Intersection ID: 53212	Main Street: IDLEWILD_RD	Cross Street: E_INDEPENDENCE_RA	Location:	SW
ADA ID: BA5A7451F576	Ramp Type: Perp	Initial Pass/Fail: Fail	Overall Compliance: No	Severity Score: 13.75

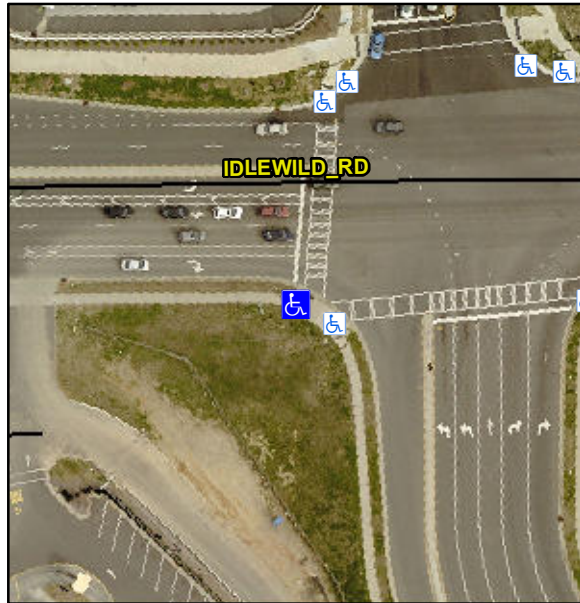
R304.2.2

Compliance	Description	Data	Compliance	Description	Data
N/A	Ramp Length (in)	66.0	No	Ramp Slope (%)	10.6
Yes	Ramp Width (in)	59.0	Yes	Ramp XSlope (%)	2.6
N/A	Flare Type LT	N/A	N/A	Flare Type RT	N/A
N/A	Flare Slope LT (%)	N/A	N/A	Flare Slope RT (%)	N/A
N/A	Flare Traversable LT?	N/A	N/A	Flare Traversable RT?	N/A
N/A	Landing Length (in)	N/A	N/A	DWS Provided?	N/A
N/A	Landing Width (in)	N/A	N/A	DWS Contrast?	N/A
N/A	Landing Slope (%)	N/A	N/A	DWS Length (in)	N/A
N/A	Landing X Slope (%)	N/A	N/A	DWS Full Width?	N/A
N/A	Landing Curb? (Y/N)	N/A	N/A	DWS Offset (in)	N/A
N/A	Shared Landing?	N/A			
N/A	Gutter Ponding?	N/A	N/A	Gutter Slope (%)	N/A
N/A	Gutter Lip Ht (in)	N/A	N/A	Gutter X Slope (%)	N/A
N/A	Painted X Walk1?	Yes	N/A	Painted X Walk2?	N/A
	X Walk 1 Direction	To N		X Walk 2 Direction	N/A
N/A	X Walk 1 Width (in)	112.0	N/A	X Walk 2 Width (in)	N/A
	X Walk 1 Slope (%)	3.5		X Walk 2 Slope (%)	N/A
	X Walk 1 X Slope (%)	3.9		X Walk 2 X Slope (%)	N/A

Remove & Replace Entire Ramp.
